TOWN OF GLASTONBURY

**PARKS & RECREATION OFFICES RENOVATIONS
2143 MAIN STREET
GLASTONBURY, CT 06033**

ADDENDUM #1

Dated: 04/14/2011

Projection
Screen Detail

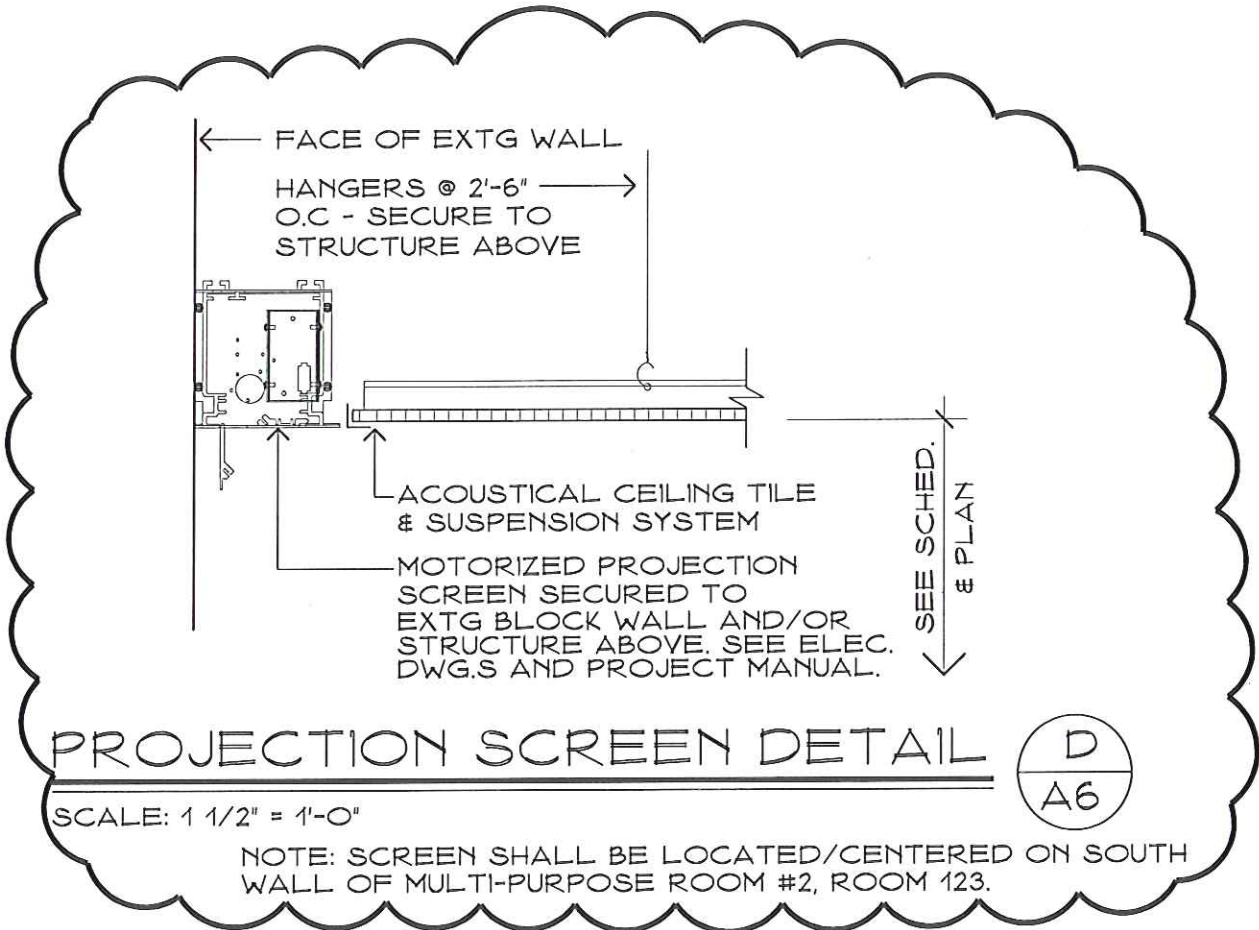
DRAWING SK1, PROJECTION SCREEN DETAIL, has been added and is attached as part of this addendum.

DRAWING E3, POWER PLAN, Multi-Purpose Room #2 123: Move specified horn/strobe on South wall west to allow for projection screen installation. Provide 120V connection from room receptacle circuit to projection screen installed in ceiling at South wall. Provide box for and installation of screen control switch furnished with unit.
